**Odisha Skill Development Authority (OSDA) Niyojan Bhawan, Sriya Square, Unit 3, Bhubaneswar – 751001 Odisha India. Tel: +91 0674 2391320/ +91 9535533255 Website: www.empmissionodisha.gov.in; Email: wsc.osda@gmail.com**

**ADDENDUM AND CORRIGENDUM**

In reference to Odisha Skill Development Authority, NOTICE INVITING TENDER Loan 3539 – IND: Odisha Skill Development Project (OSDP) dated Nov 17th 2018, following changes has been done:

**Package 2 –Residential Air-Conditioning**

(figure 1)

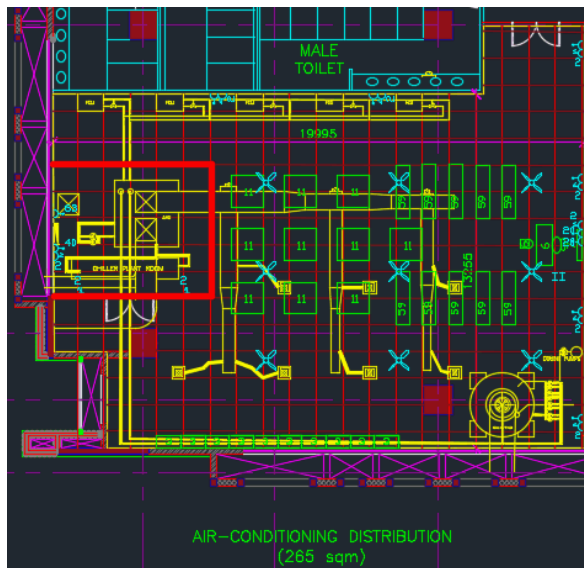
Based on tender Corrigendum, the tonnage of Chilled water balancing distribution trainer should be reduced to appropriate capacity as per room size requirement (325 sqm).

We have been looking more detail on room size and Workshop layout and found there are two workshops that are dedicated for Residential Air-Conditioning Services; on 3<sup>rd</sup> floor (225sqm) and 7<sup>th</sup> floor (280sqm).

From both of Residential airconditioning workshops layout we still not clear and could not find the area for Chilled water balancing distribution.

1. The chilled water balancing distribution system is under the air distribution system. It is not related to the residential air conditioning workshop.

The above stated equipment should be placed in the workshop shown here in figure 1:

3. Size of the chiller and air conditioning system only needs to be large enough to accommodate for the size of the workshop (265 sqm) (Shown above in figure 1.)

(figure 2)

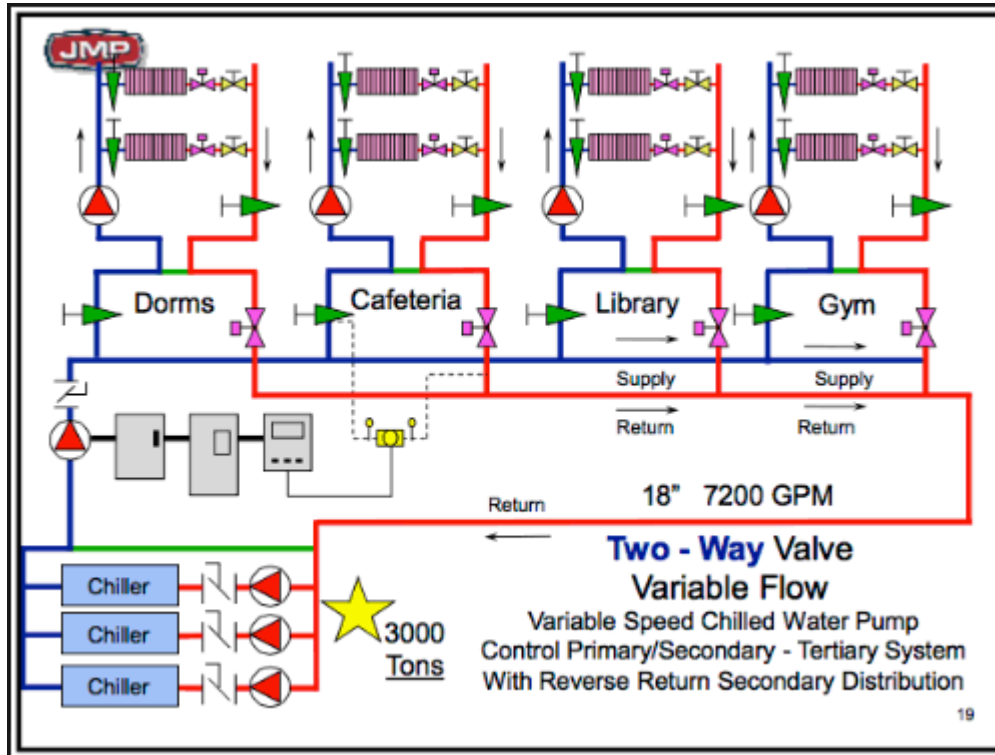
This package is not provided with a detail technical specification but it comes with Technical Drawing.

Refer to Technical drawing, the system should consist of 3 Chillers, 8 water pumps and 8 Fan coils plus controller and some other components.

Could we have a clarification on which floor the Chilled water balancing distribution trainer will be placed?. (3<sup>rd</sup> floor or 7<sup>th</sup> floor?), and Where will the 3 chillers and cooling tower be placed? (Inside or outside the room?)

2. Figure 2 mentioned above is only a **schematic sample**. It is not meant to be the actual set up for the workshop. For actual workshop, please refer to figure 1 above.
